22.06 REGULATION

4TH AHG MEETING

SEPTEMBER, 2ND, 2021

FROM INDUSTRY

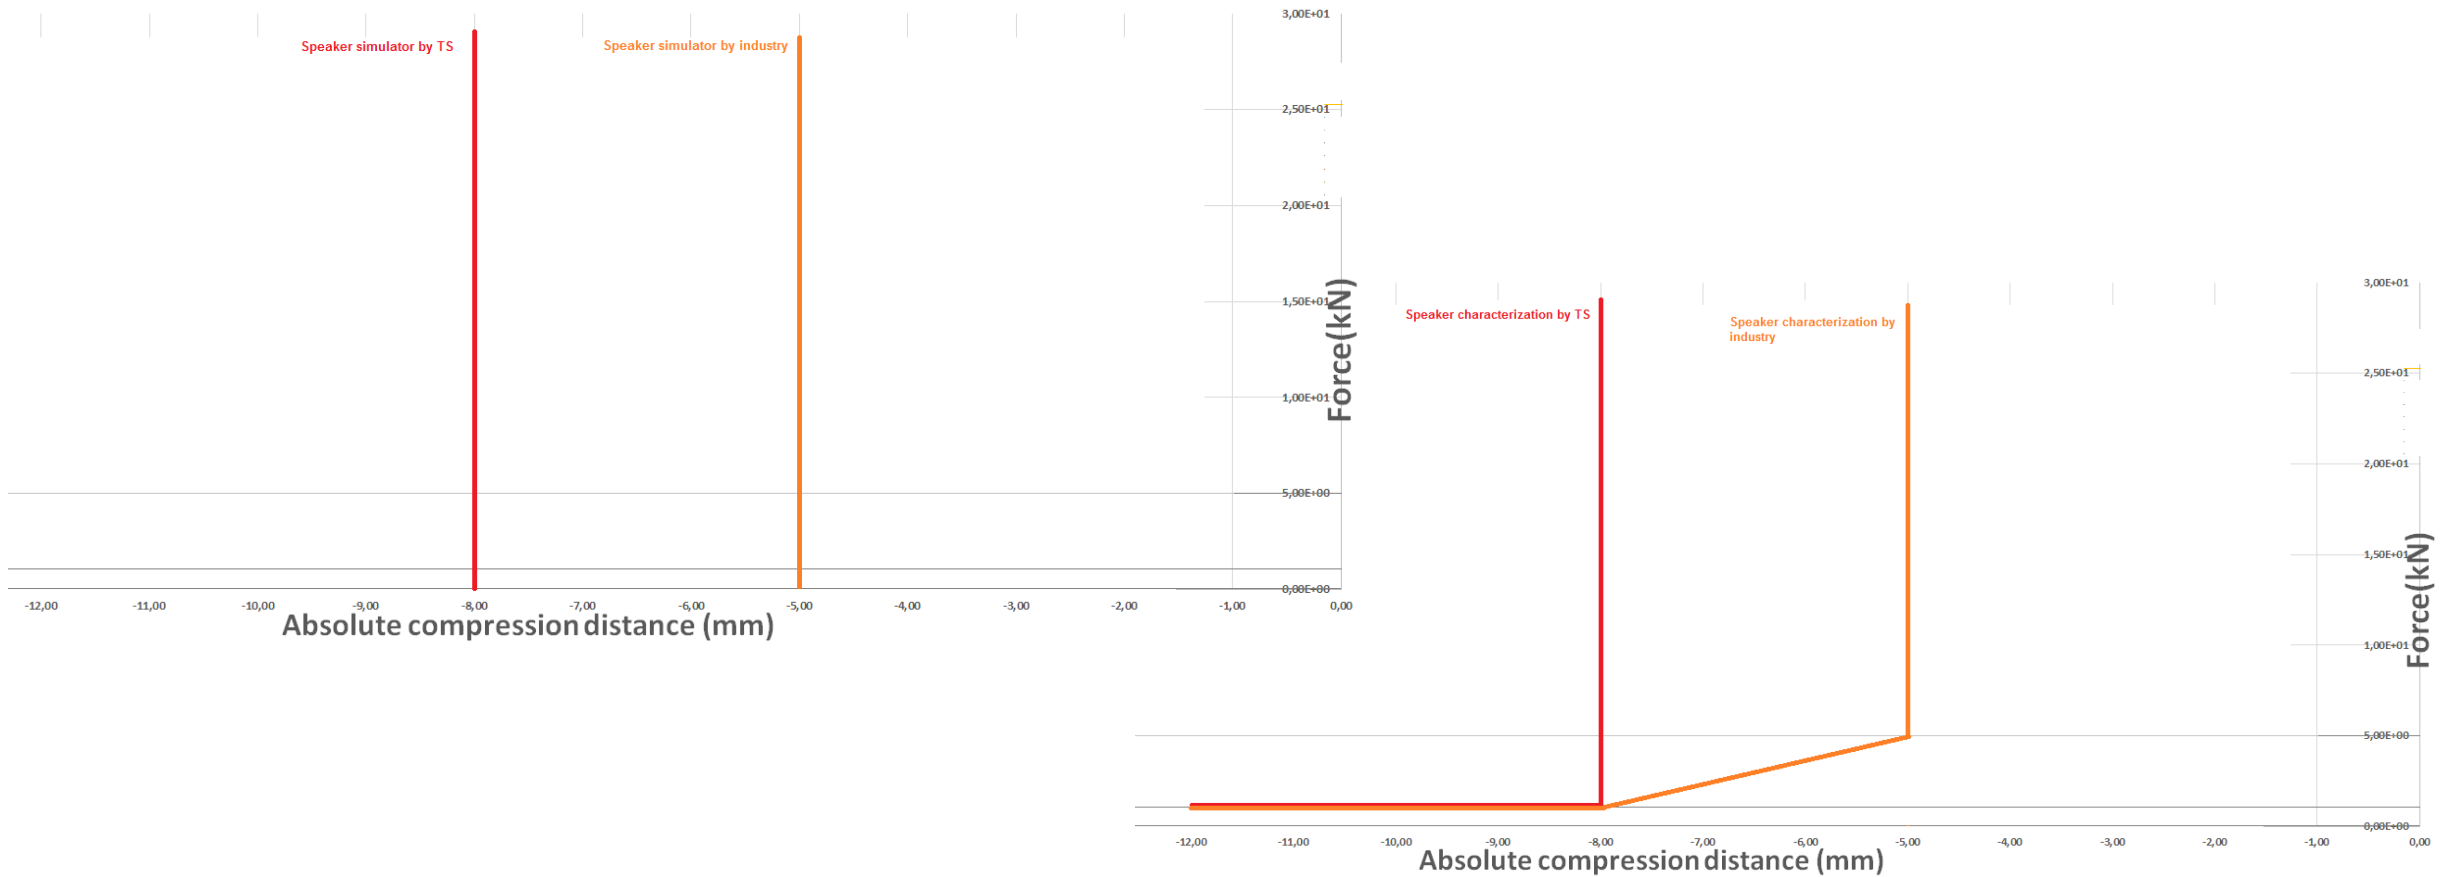
Items which have been modified:

- ✓ Bonding surface. The helmets ready for universal accessories must foresee a special preparation on the inner EPS to allow the clamping of externally fitted Universal Accessories OR have a proper surface in the external part of the outer shell to allow the bonding of the UA.
 - Surface shape and dimensions defined
 - Location of the bonding surface defined

- ✓ Clamping free EPS space definition.
 - The dimension has to be better checked and could be slightly reduced in thickness for front and side location (Need to consider).
 - Better definition for rear clamping requirements

New proposal for speaker characterization and simulator:

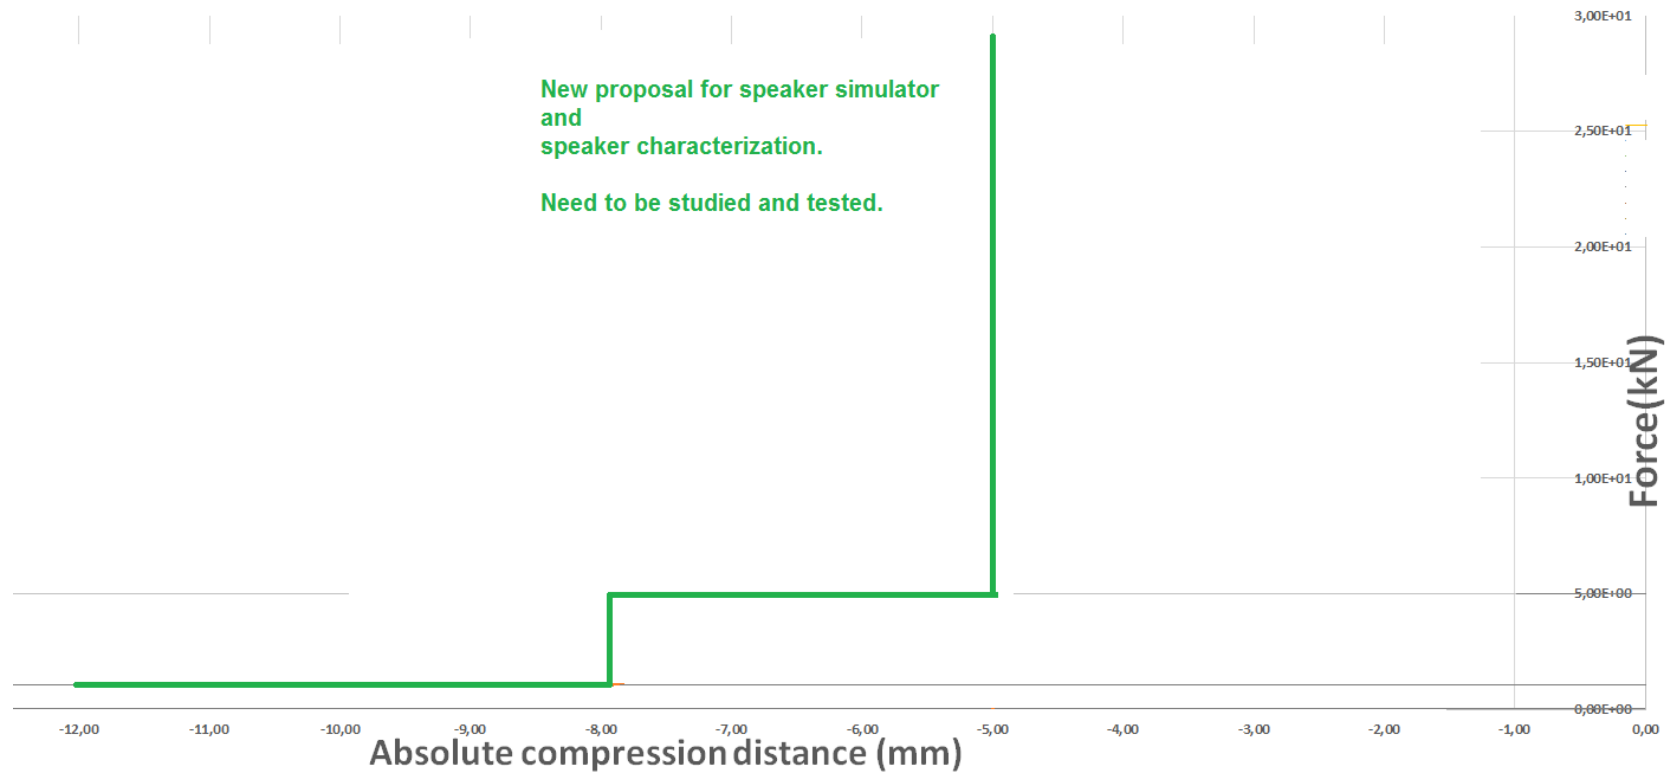
Item which need agreement:
